ADDENDUM No. 1

RFP No. AAHC 22-01

Miller Manor Fire Suppression System Upgrade

MILLER MANOR FIRE SUPPRESSION DESIGN

1 PARITAL FIRST FLOOR PLAN (SOUTH) - FIRE SUPPRESSION NEW WORK

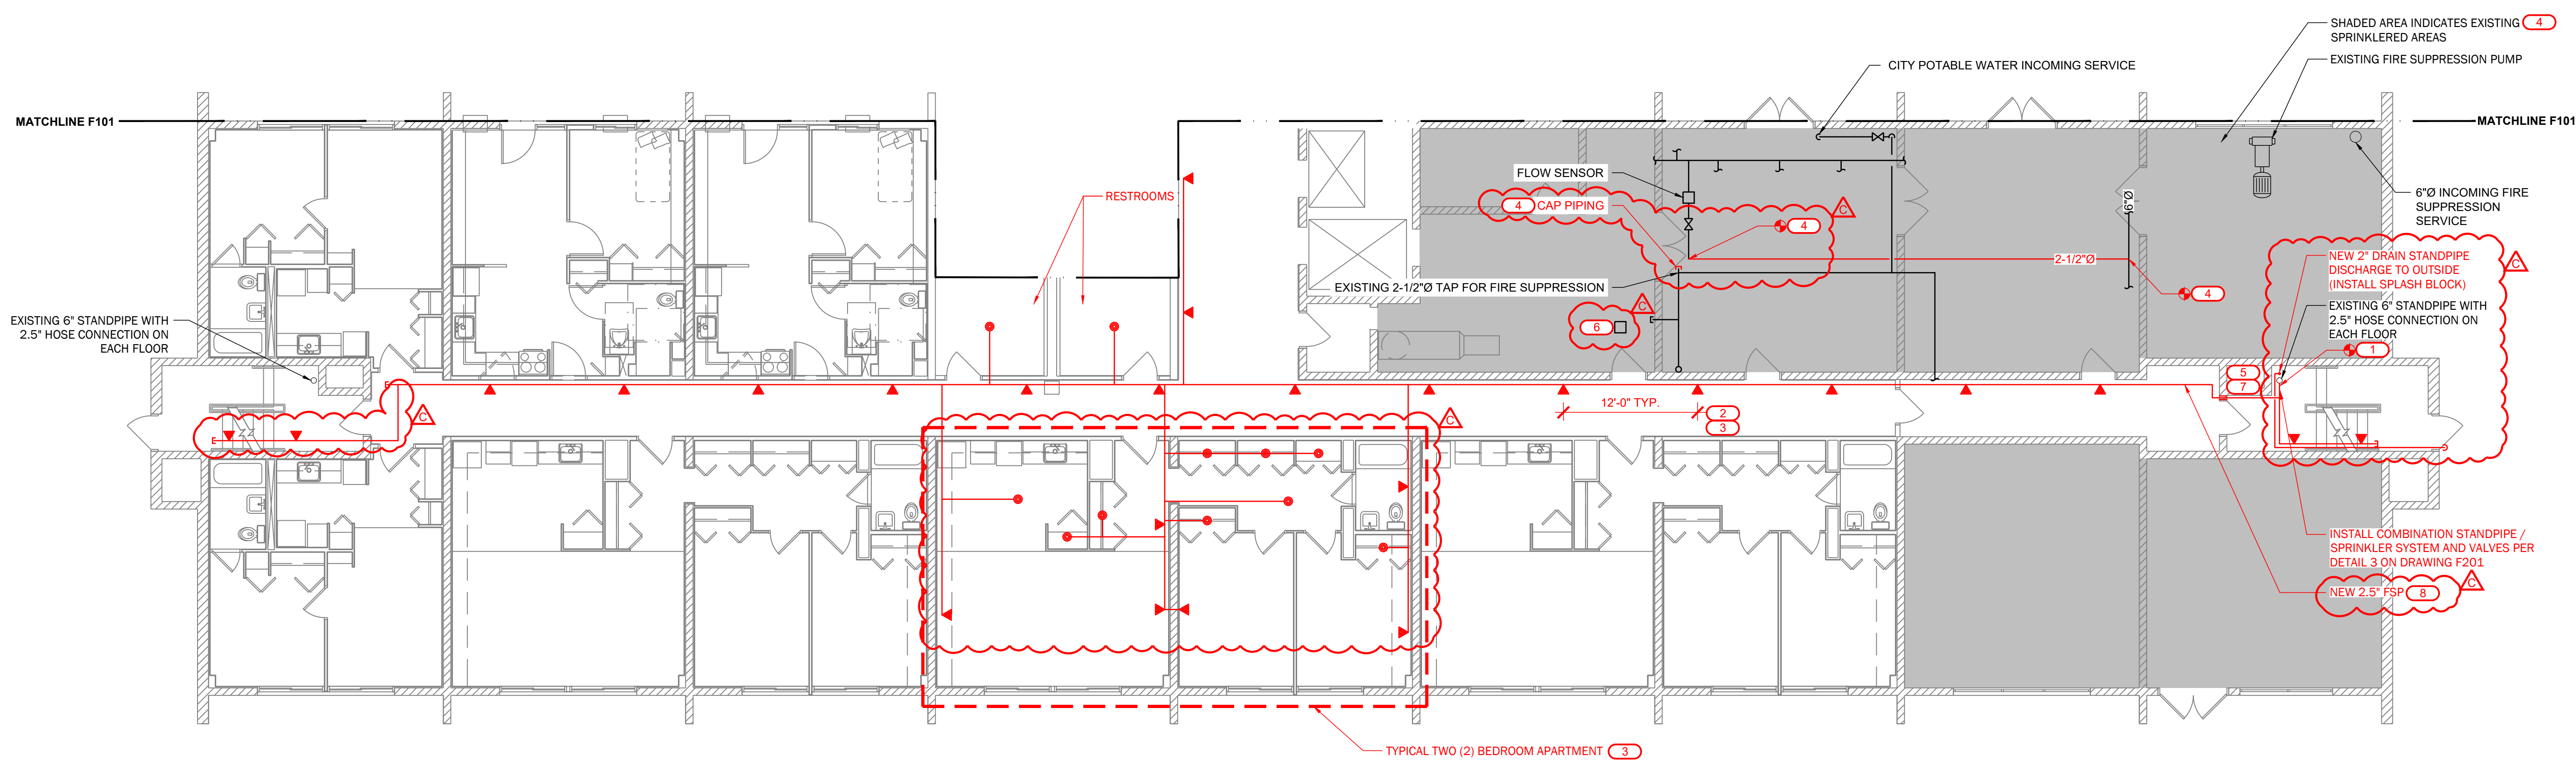
Question 1: Fire suppression in closets
Answer 1: Yes, see attached drawings

Question 2: Fire suppression system to be routed above or below ceiling on first floor?
Answer 2: Below, however the new piping cannot block any electrical junction boxes.

Question 3: Replace cover or entire flow switch in first floor trash room?

3. INSTALL NEW FIRE SUPPRESSION PIPING AND SPRINKLERS IN ALL TWO (2) BEDROOM APARTMENTS (AS SHOWN ON THIS DRAWING), AND ALL ONE (1) BEDROOM APARTMENTS (REFER TO F103 FOR TYPICAL ONE (1) BEDROOM APARTMENT).

Answer 3: Replace flow switch with new.

1 SEVENTH FLOOR PLAN - FIRE SUPPRESSION NEW WORK
1/8" = 1'-0" (24"x36" DRAWINGS)

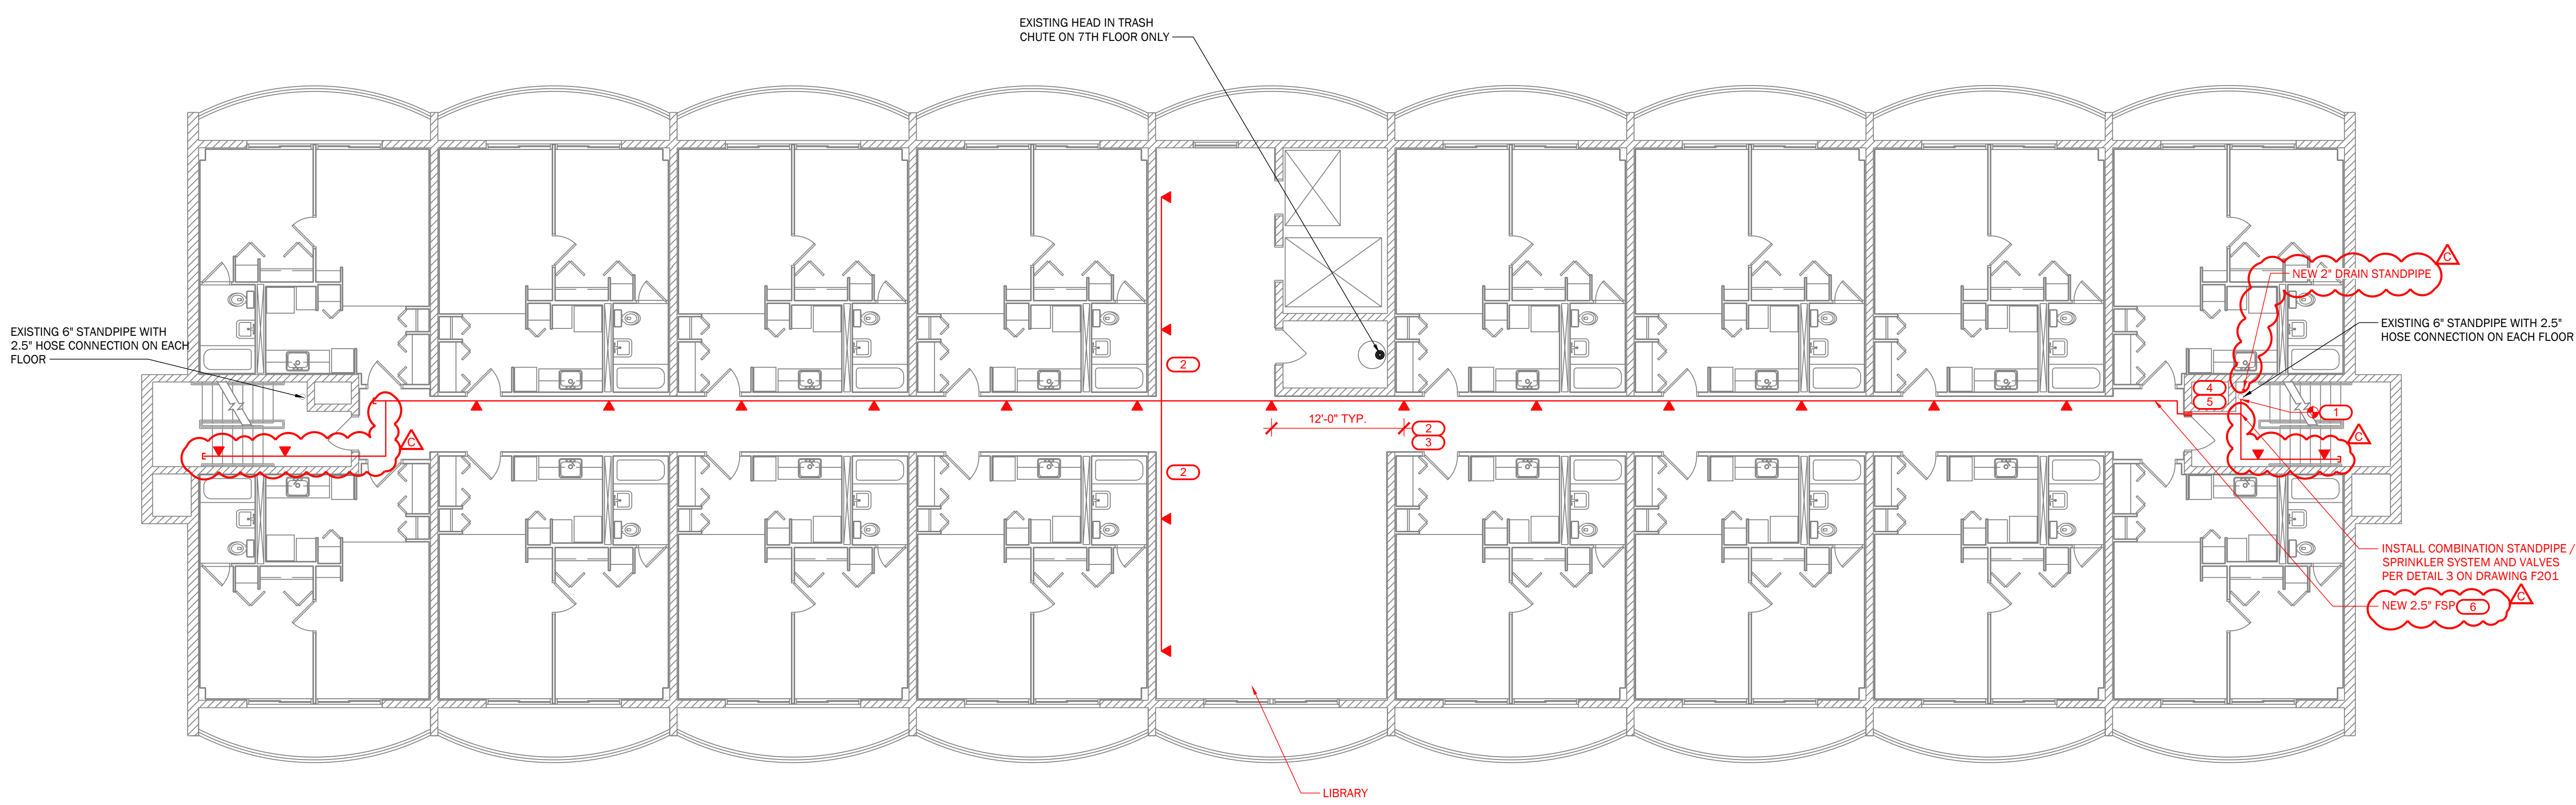
Question 5: Are we to install sprinklers on the 1st and 7th floors of the stairwell?

Answer 5: Yes
